From:
To: [Committee of Adjustment \(SM\); Sean Harrigan](#)
Cc: [Debbie Chapman](#)
Subject: Opposed to Variance Request for 96 Wood St (A-2024-075)
Date: Thursday, September 12, 2024 4:57:26 PM
Attachments: [96 Wood Street - Plan.pdf](#)

Re: A-2024-075 - 96 Wood Street

*Requesting minor variances to permit a visibility obstruction (a fence) having a height of 1.83m within one side of the Driveway Visibility Triangle (DVT) rather than maximum permitted height of 0.9m within the DVT; a lot area of 393 sq.m. rather than the required 450 sq.m; a front yard setback of 3.8m rather than the required 4.5m; an exterior side yard setback abutting York Street of 2.5m rather than the required 4m; a building height of 12m rather than the maximum permitted 11m **to facilitate the redevelopment of the property into an 8-unit multi-residential dwelling.***

SITE PLAN
SCALE: 1 : 150

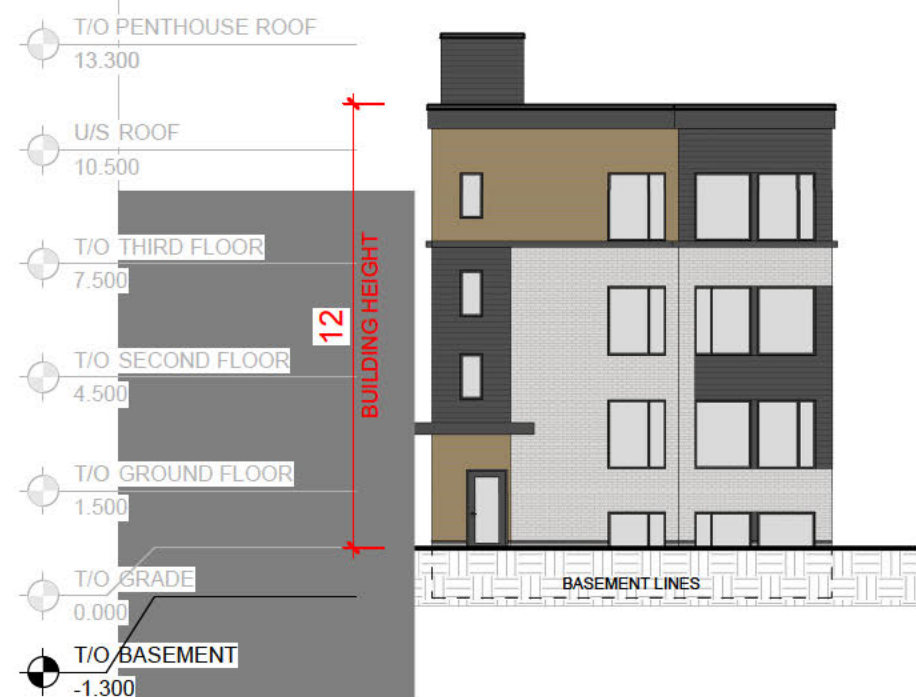
The application does not provide details on waste and recycling storage, which is crucial for the quality of life of adjacent homeowners. The lack of information about waste management and the apparent absence of designated outdoor space for waste enclosures are concerning.

The absence of a tree preservation plan is troubling, especially since there are significant growth and old-growth trees on the property. These trees contribute to the character of our neighborhood, and their preservation should be a priority.

EAST ELEVATION (WOOD STREET FACADE)
SCALE: 1 : 200

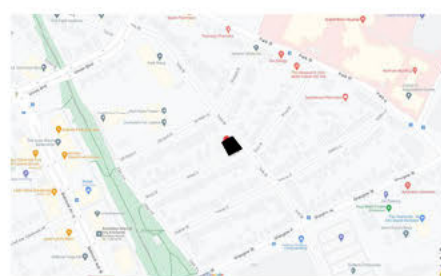
The proposed building's size and height are disproportionate compared to existing structures in the neighborhood. According to the Urban Design Manual, new buildings should respect the existing context and massing, avoiding significant discrepancies in size. The proposed building appears significantly larger and does not reflect a harmonious integration with the surrounding structures.

The design presented is described as "contemporary/modern cookie-cutter" and lacks elements that reflect the character and heritage of our neighborhood. The Urban Design Manual emphasizes the importance of integrating new developments with the existing architectural rhythm, including respect for building height, setbacks, and materials. The proposed design does not seem to align with these guidelines and fails to complement the existing development patterns.
